# Safety Evaluation Report

related to the operation of  
San Onofre Nuclear Generating Station,  
Units 2 and 3

Docket Nos. 50-361 and 50-362

**U.S. Nuclear Regulatory  
Commission**

Figure 361.45 - 1 Empirical Plot  
Geologic Slip Rate VS Historical  
Magnitude for Strike-Slip Faults

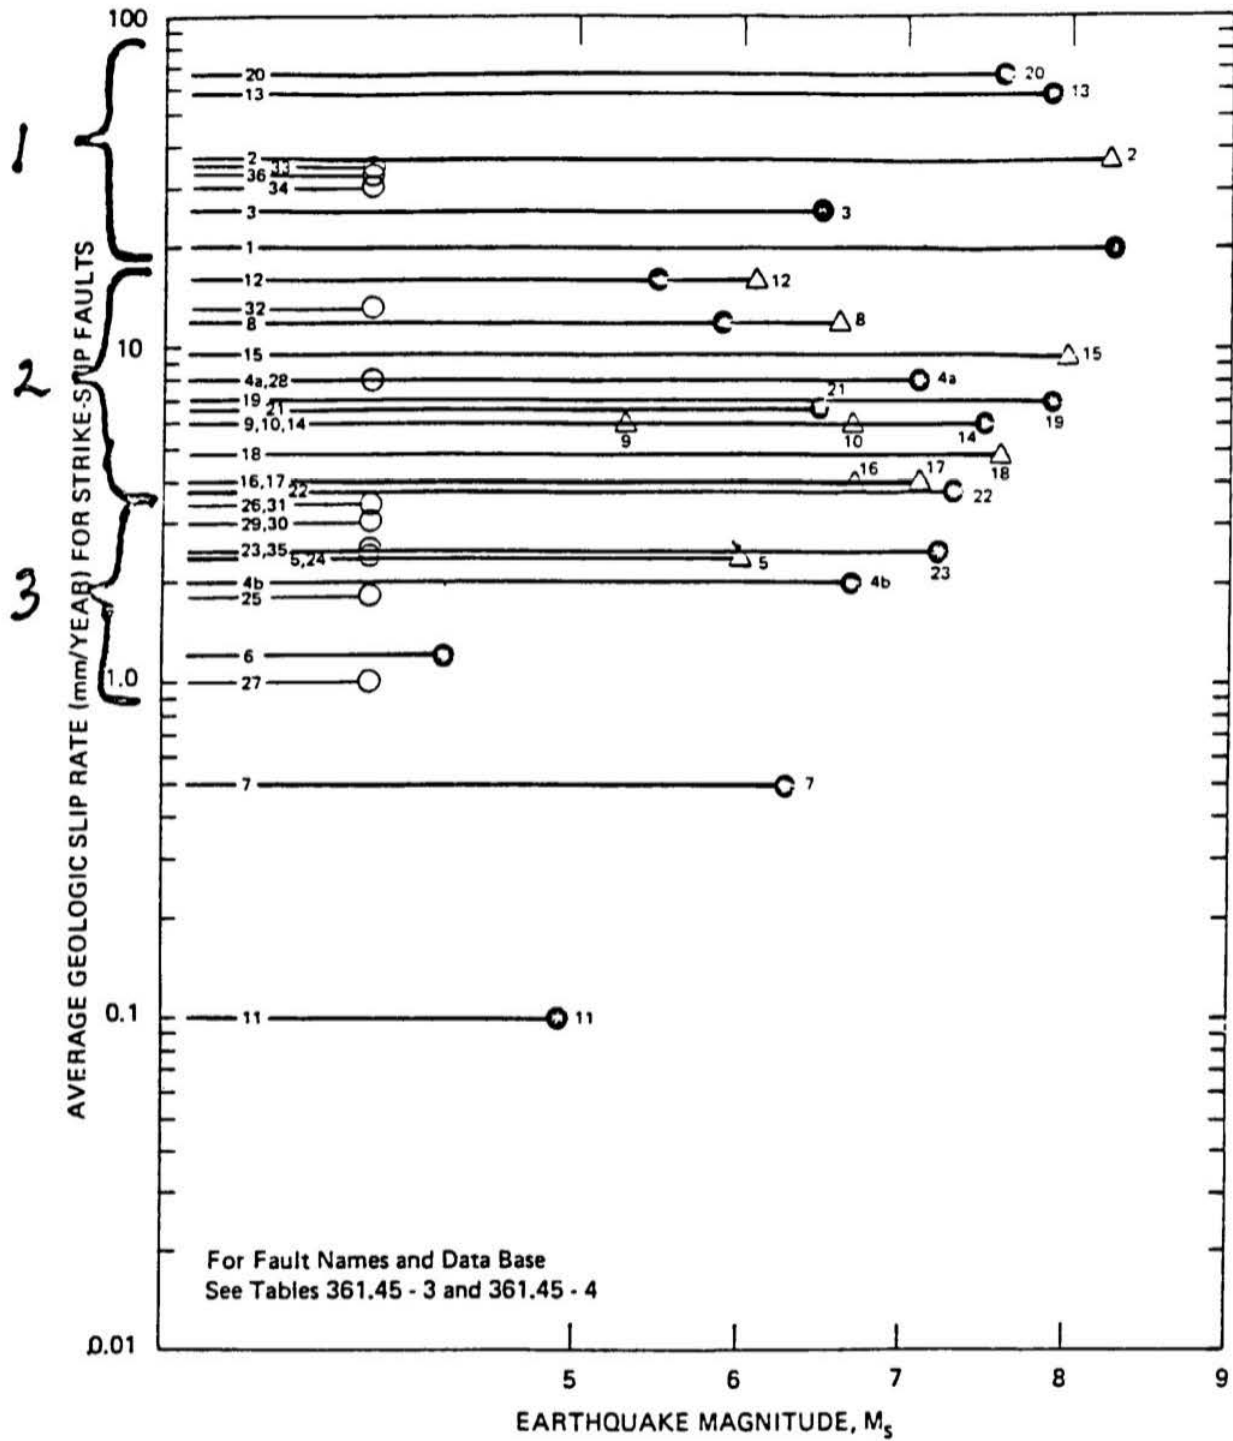
However, in an effort to be responsive to your requests to review the material submitted by the applicant, we offer the following comments concerning the primary technique discussed by the applicant, slip-rate versus magnitude study.

On the question of the statistical significance of the slope of a line bounding points on the log slip-rate versus magnitude plot, the applicant's consultants point out that while a single fault with low slip-rate is unlikely to have a "maximum" earthquake in historic time, a group of low-slip-rate faults has a significance proportional to their moment-rate sum. This same reasoning can be applied quantitatively.
